COMMENTS BY RALPH B. PECK

(Reconstructed from notes prepared 17 & 18 July 1979)

MIDLAND PROJECT - FOUNDATION PROBLEMS

Meeting with Soil Consultants at Denver Colo

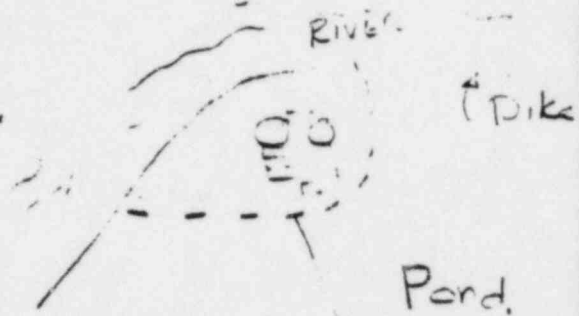
3. Consultants need more information regarding Aux. Bldg. Electrical Penetration Area foundation design to arrive at a viable fix. They urged a parametric type of study for the ground and structural conditions.

This study would enable to narrow down the choices, such as whether to put caissons obtain lateral support by attaching the floor to containment and turbine building. Most attaching the slab to valve pit structure or the use of 'raking' caissons.

They suggested that instead of underpinning the valve pit structure, the structure can be replaced with another one with better foundation or with lean concrete fill extending down to till.
